Amphenol PCD

Engineering Change Request		ECR Number	R10167W
Initiator:	Scott	Date:	2026/04/10

Item	K3 Code material part numbers	Drawing/ Doc Number	Version of current related document	New Version
1	MSDXL Series	/	/	/

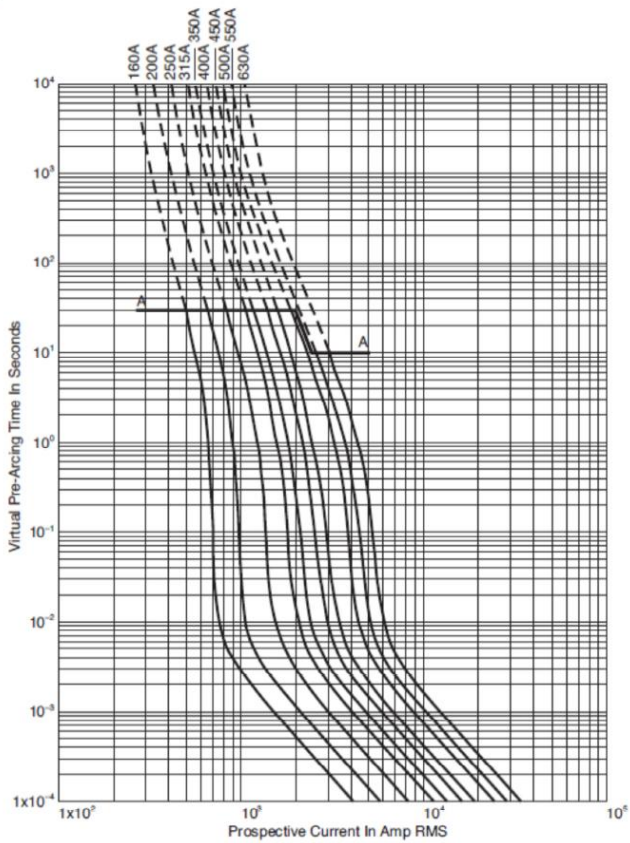
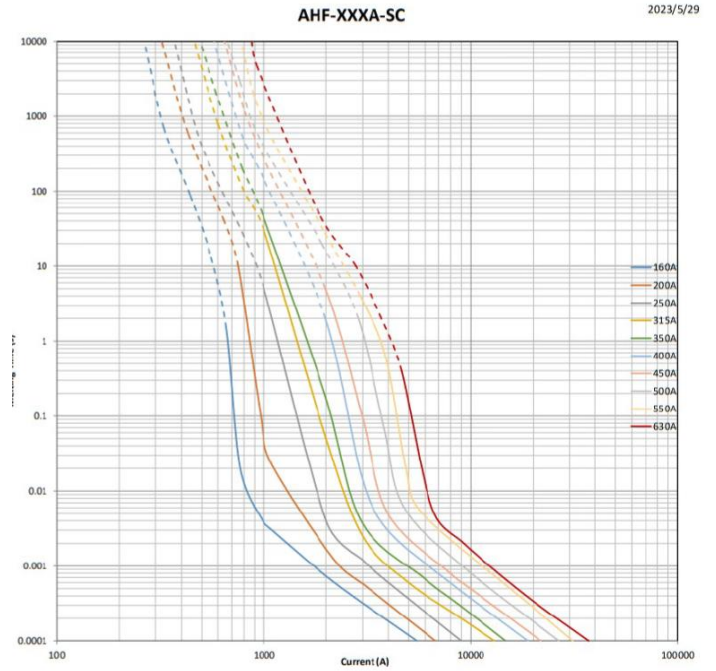
Due to the continuous and uncontrollable price increase of precious metal materials in the global market, in order to keep the cost of the MSDXL series products within a reasonable range, while maintaining the same fuse function and appearance, the internal fuse element is changed from pure silver to a copper-silver composite material.

Before change

STERLING SILVER -Time-current curves

After change

COPPER SILVER COMPOSITE -Time-current curves

The following is a comparison of the curves for silver and the copper-silver composite:

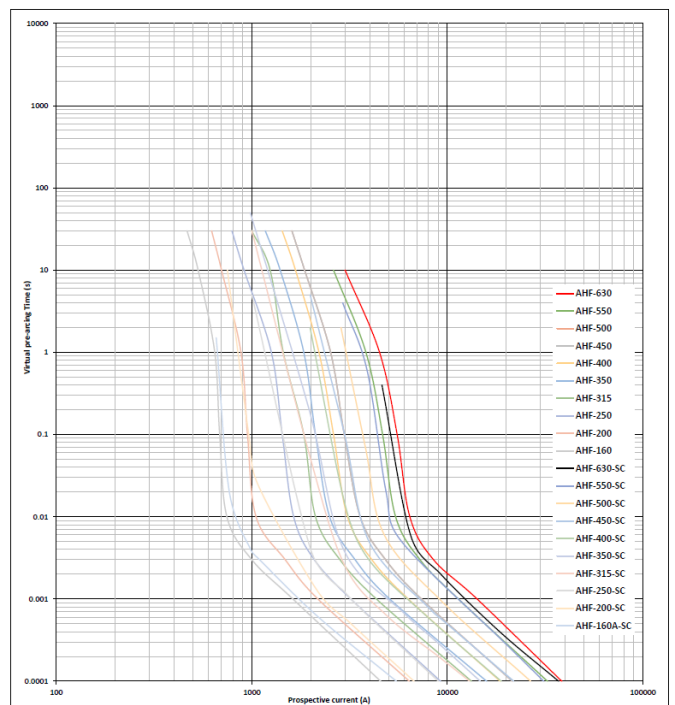
1. Model: AHF-160 – curve for silver
2. Model: AHF-160A-SC – curve for the copper-silver composite (the specification after the material change)
3. High overlap of curves for the same specification.
4. The T-C curve itself has a protection tolerance band of $\pm 15\%$.
5. Small differences in short-circuit protection across the series of curves.
6. The T-C curves of copper-silver composite strips are all slightly faster than those of pure silver, and the matching effect with relays will get better.
